REMARKS/ARGUMENTS

Serial No.: 09/545,367
Amendment dated August 27, 2003
Reply to Office Action of June 27, 2003

FIG. 16

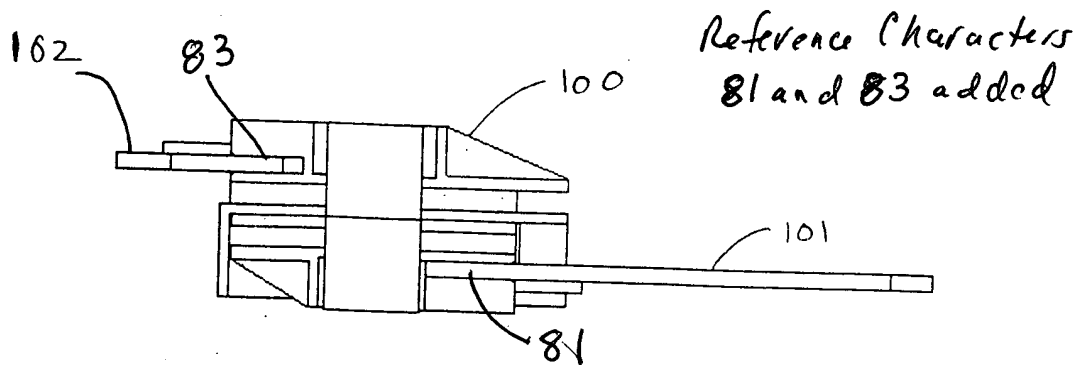
In Figures 16 and 17, as amended, the previously omitted reference characters 80, 81, and 83 have been added. This drawing correction is supported by the specification and drawings as filed. No new matter has been added. As stated in the specification (e.g., page 3, line 10 - page 4, lines 4): FIGs. 1 to 3 show different isometric views of the transformer 100 according to an embodiment of the invention; FIG. 16 is a side view of a transformer, identified as 100, disposed between two circuit boards; and FIG. 17 is a top view of the transformer 100 disposed between two circuit boards.

Reference character 81 has been added in FIGs. 16 and 17 in order to further clarify these drawings. FIG. 2 shows another view of the transformer 100. As shown in FIG. 2 and described in the specification (e.g., page 8 lines 13-22), the first bobbin member 40 of transformer 100 may include a recess 81 (e.g., a slot) for receiving a printed circuit board.

Reference character 83 has been added in FIGs. 16 and 17 in order to further clarify these drawings. FIG. 3 shows another view of the transformer 100. The specification has been amended to correct a minor typographical error. As shown in FIG. 3 and described in the specification, as amended herein, (page 8, line 23 - page 9, line 6), transformer 100 includes a

Reference Characters
80, 81, and 83
added

FIG. 17

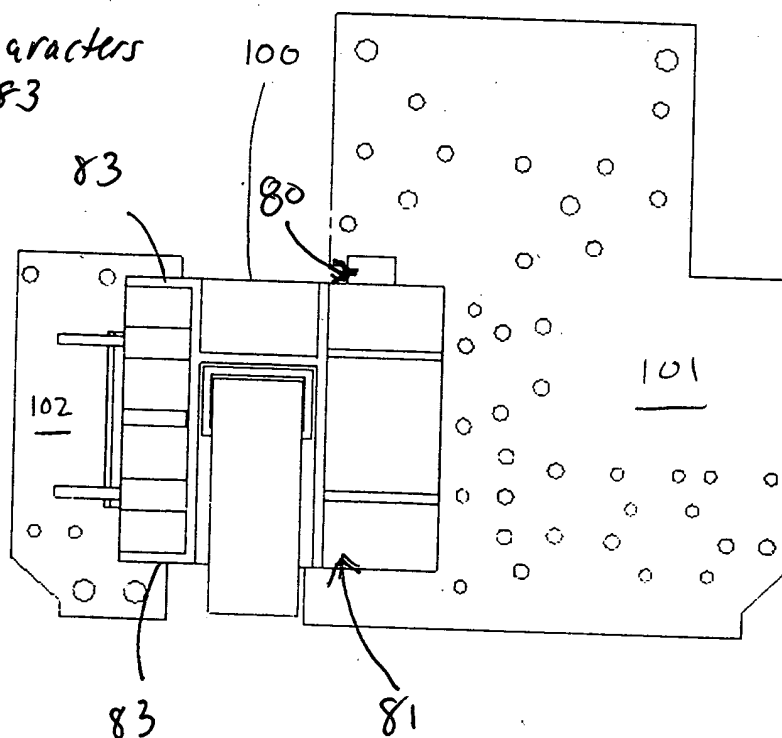
Reference character 80 has been added in FIG. 17 in order to further clarify the drawing. Element 80, also shown in FIG. 1, is a structure for receiving a circuit board. As shown in FIG. 1 and described in the specification (e.g., page 6 line 20 - page 7, line 4), structure 80 includes two protrusions extending away from an outer surface of one of the flange portions 21(a). When a circuit board is mounted to the flange portion 21(a), the circuit board is sandwiched between the protrusions and is parallel to the walls 26, 27, 46, 47 of the bobbin members 20, 40.
